**TOWN OF CARMEL**  
**PLANNING BOARD**

**PLANNING BOARD AGENDA**  
**AUGUST 5, 2015 – 7:00 P.M.**

RE: Baldwin Subdivision  
Route 6  
Tax Map No. 86.11-1-1

RE: PCSB Site Plan  
Route 6  
Tax Map No. 86.11-1-1 – Proposed Lot 1

DRAWING:  
**EROSION & SEDIMENT CONTROL PLAN**

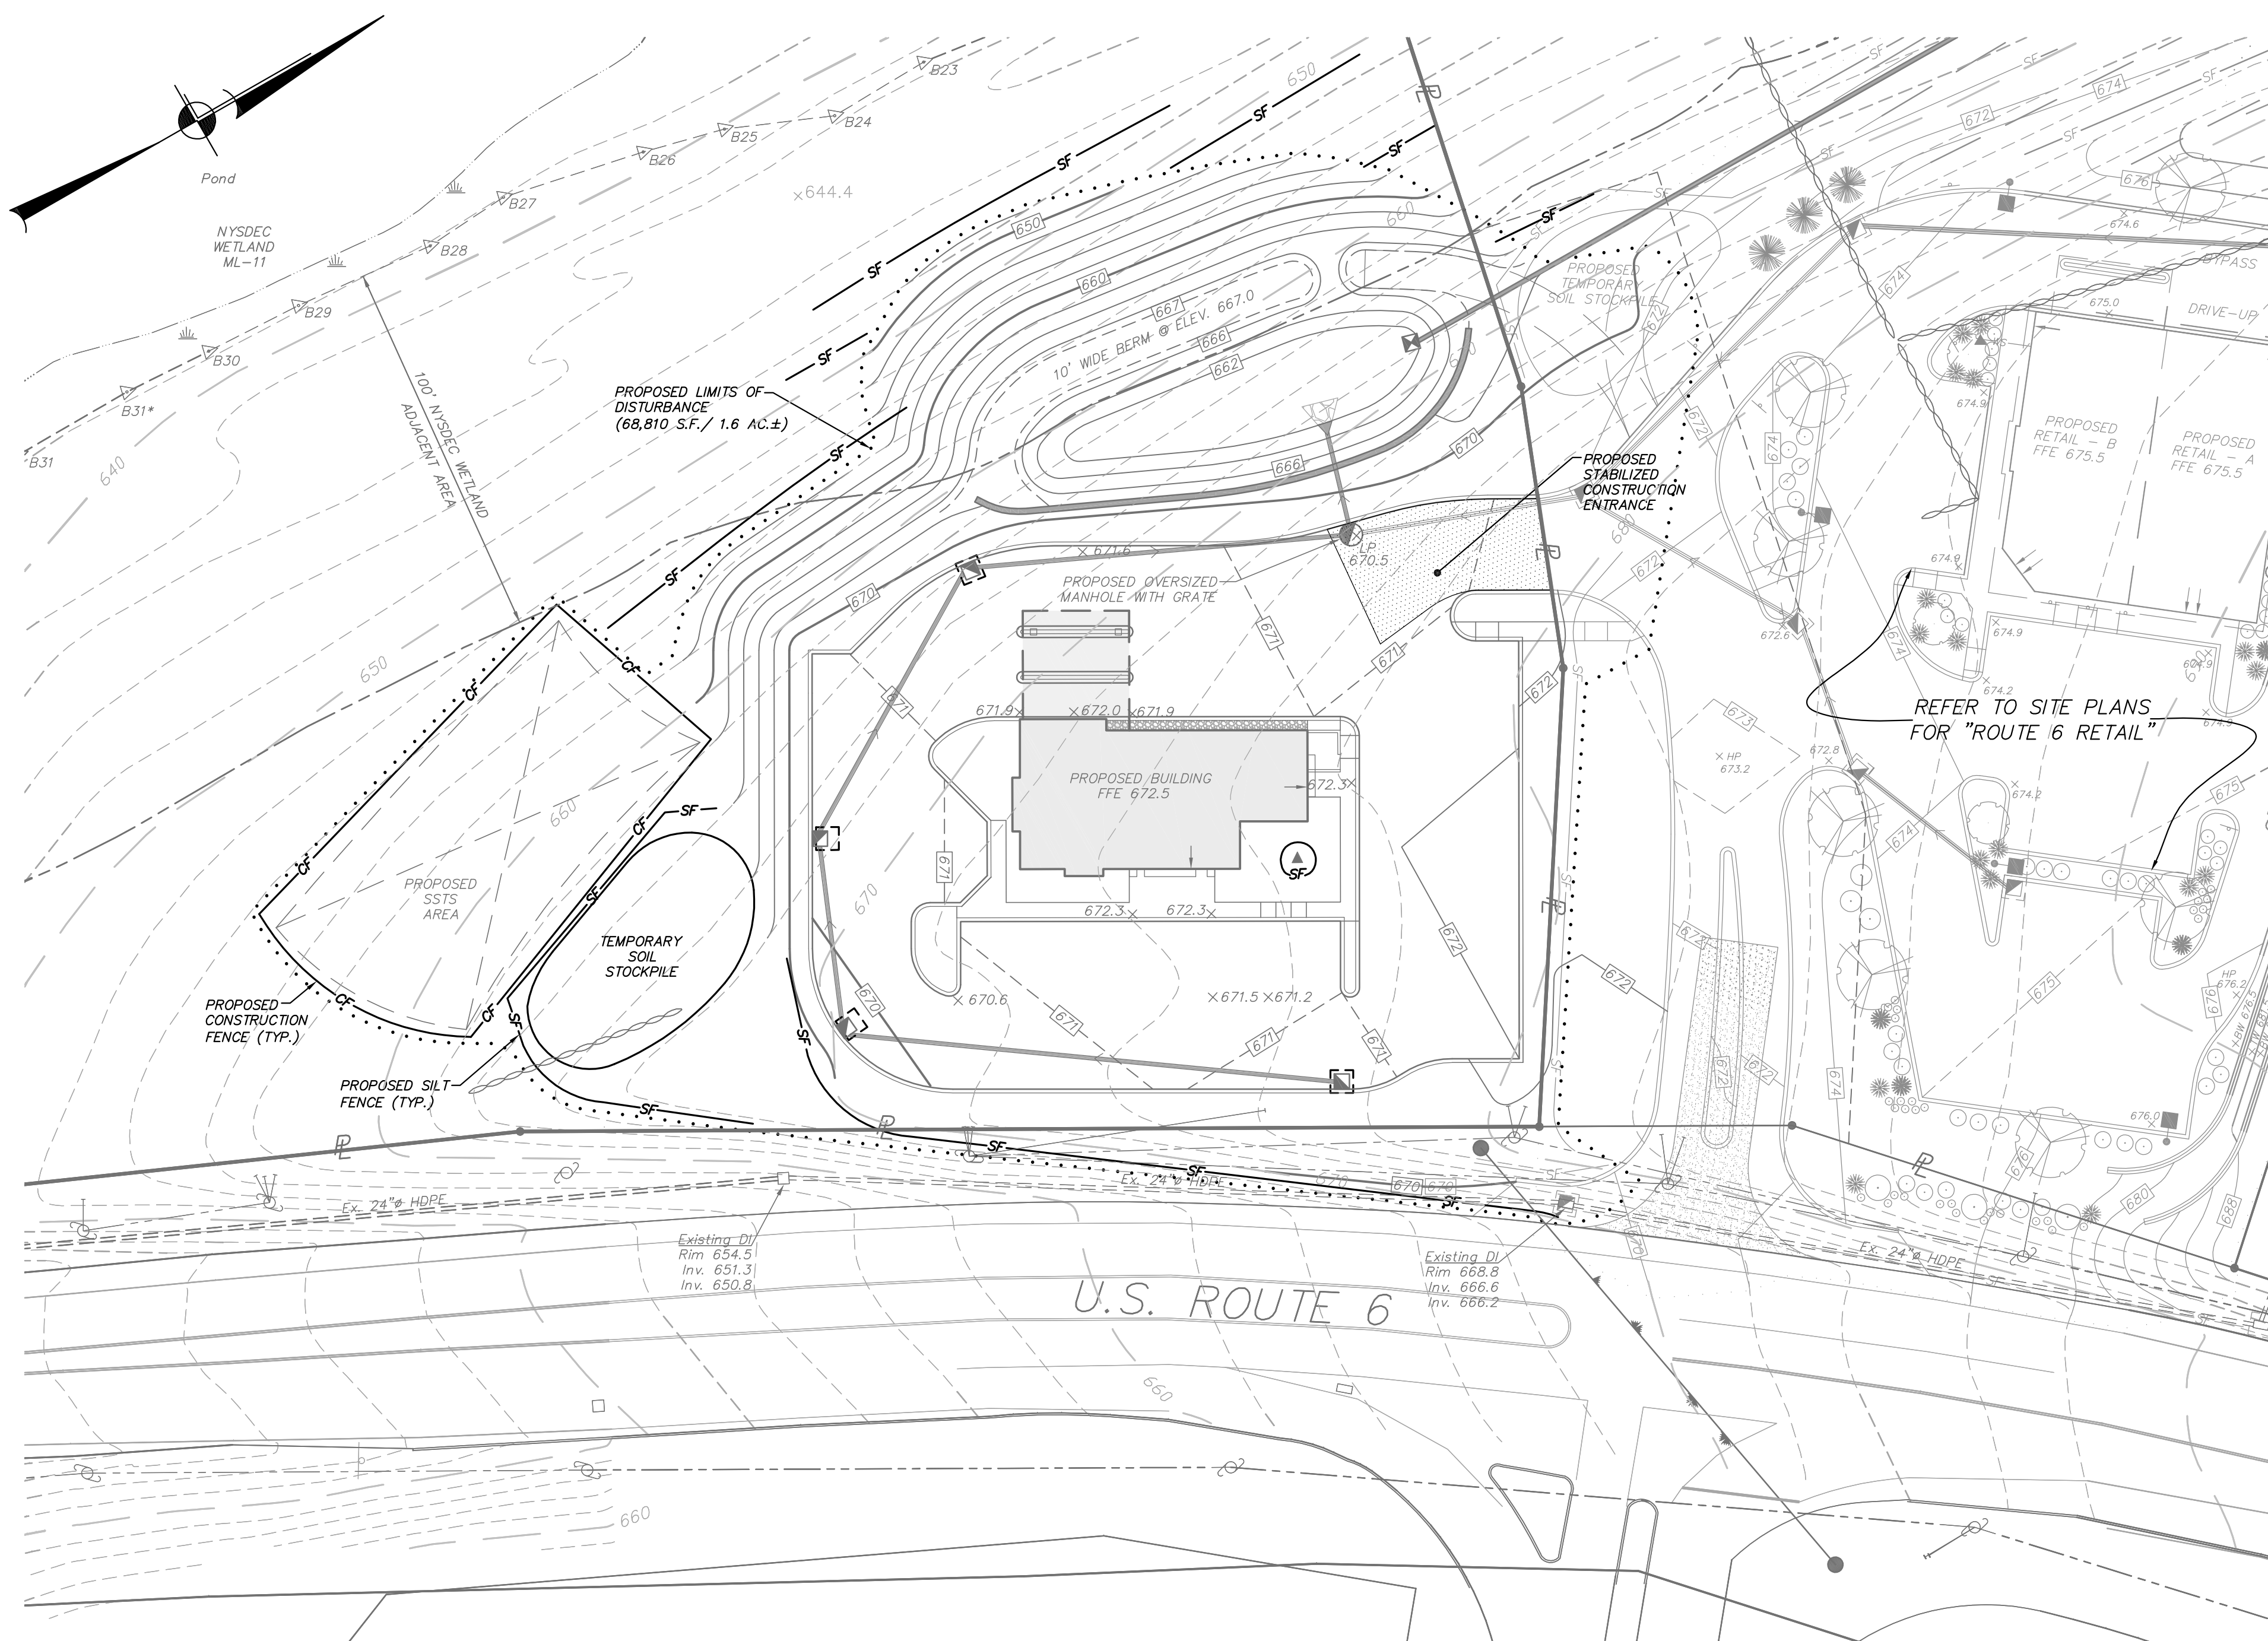
- e. See response to Item 3.d. above.
  - f. See response to Item 3.d. above.
4. Erosion and Sediment Control Plan – SP-3
  - a. Rim and invert elevations shall be provided in a later submission.

- b. A SWPPP shall be prepared and provided in a later submission.
5. Site Details – D-1 and D-2
  - a. The concrete sidewalk and curb details have been revised to meet the criteria defined in Section 128 of the Town code.

**HDPE END SECTION DETAIL**  
(N.T.S.)

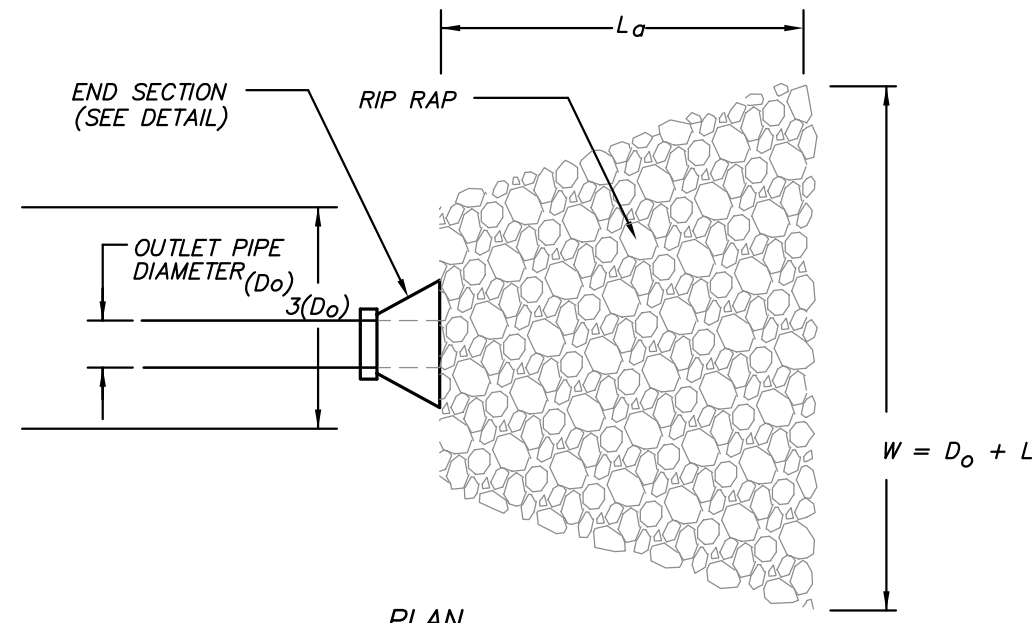
- b. The end section material shall be HDPE to match the contributing drainage pipe. This has been added to the End Section Detail.
